Anthony Mungall,
Senior Manager Transmission Policy
Ofgem
107 West Regent Street
Glasgow
G2 2QZ

10th October 2013

Project TransmiT: Impact Assessment of industry's proposals (CMP213) to change the electricity transmission charging methodology - RWE response

Figure 1: Power Station annual load factors 2008-13 (RWE Analysis)

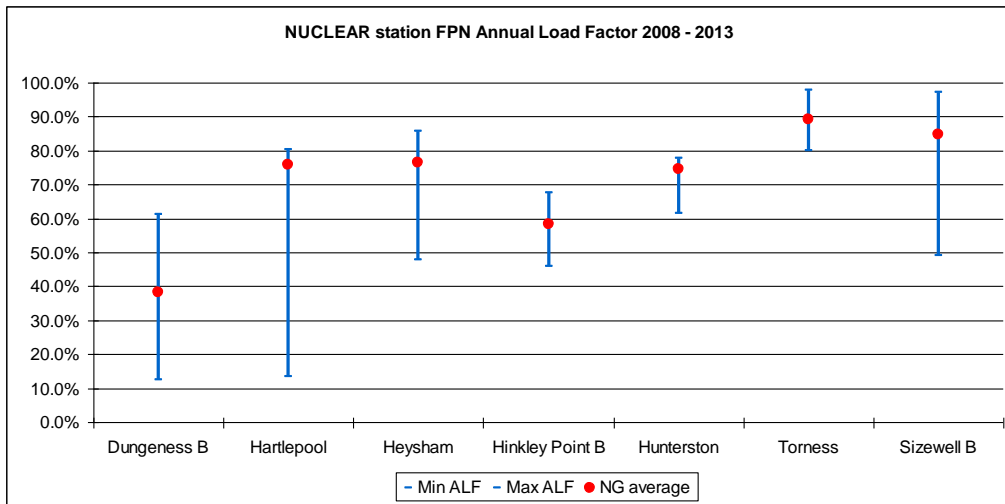
- **The use of historic load factors which do not provide a sound basis for predicting future usage of the transmission system:** The ALF data used in the allocation of prospective user tariffs (year round * ALF) is based on baseline load factors for a 5-year period. This data is derived from the years immediately prior to the year in which the charges are calculated and will apply for the next charging period. As illustrated in the Modification Report the data is an inaccurate and unreliable proxy for future use of the transmission system. For example, while the average difference in 5-year load factors is 13% and 16% for 2010/11 and 2011/12 respectively, the *maximum* absolute difference is 44% and 58%²⁸ Our own work illustrates the variability of historic load factors (Figure 1)

The observed ALF for CCGTs can vary between 0 and near 100%. The NGET method of deriving an average varies over the range 10% to 95% across CCGTs. The ALFs for nuclear power stations also indicate a wide range of output despite the fact that it is argued that this plant type is fossil fuel price independent and should operate at a more

or less constant average ALF with differences between years being attributed to planned maintenance and re-fuelling, and unplanned outages.

Consequently the historical nature of the data and its inaccuracies mean that the load factor cannot reflect the prospective use of a user in the relevant charging year. Therefore, the charges calculated under the CMP213 WACM2 methodology cannot be cost reflective.
